Docket Item #8
BAR Case #2006-0008

BAR Meeting
February 1, 2006

ISSUE: Re-approval of addition and alterations

LOCATION: 217 North Saint Asaph Street

Figure 1 - Rear (east) elevation

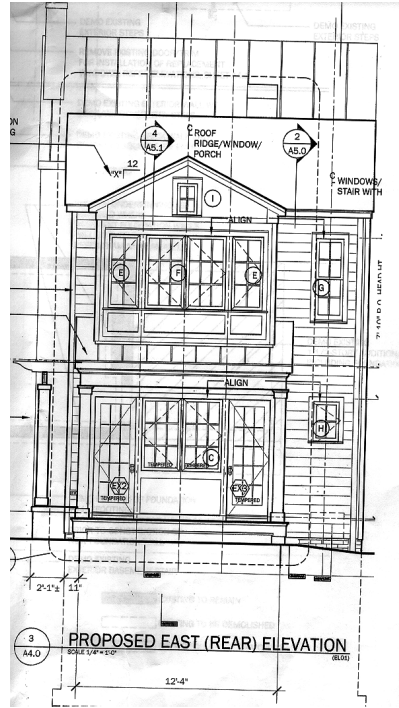
will be composed of wood windows with wood trimmed MDO panels below. The south side of the sunroom will have a pair of eight-light casement windows on each story. The sunroom section will cover the southernmost two thirds of the rear (east) elevation of the addition. The northern bay of the new addition will have a small four-light casement in the first story and a narrow four-over-four double hung window in the second story. The sunroom section will have multi-light doors on either end with a pair of nine-light casement windows between them and wood panel below. The second story of the sunroom section will have four casement windows ganged together. The outer two will be six-light will the center two will be nine-light. The north elevation of the addition will be clad in wood siding and will be blind. The sunroom section will have a pair of eight-light casement windows in the first story and a pair of six-light casement windows in the second story. A shed roof porch, the same width as the sunroom section will project from the rear wall of the addition and extend 2'4" beyond the sunroom. It will be supported on wood columns and will rest on a 1 1/2' high wood deck which will extend well beyond the porch into the back yard.

Figure 2 - South side elevation

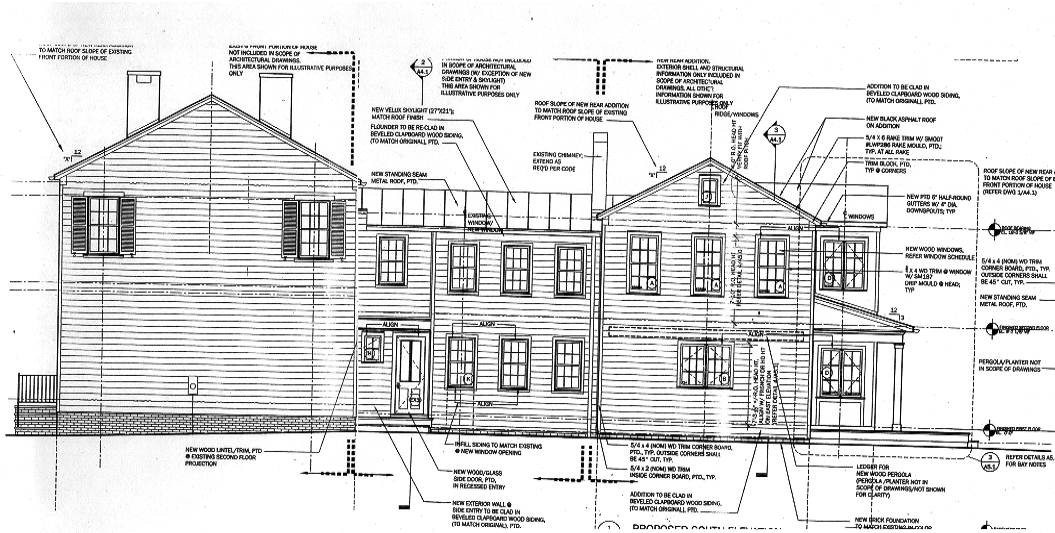
The south side elevation of the addition will have a pair of nine-light casement windows centered in the first story and three evenly spaced six-over-six double hung windows in the second story. There will be a small four-light window in the attic story. At the east end of the addition will be the two story sunroom section, projecting six feet beyond the end of the addition. The sunroom
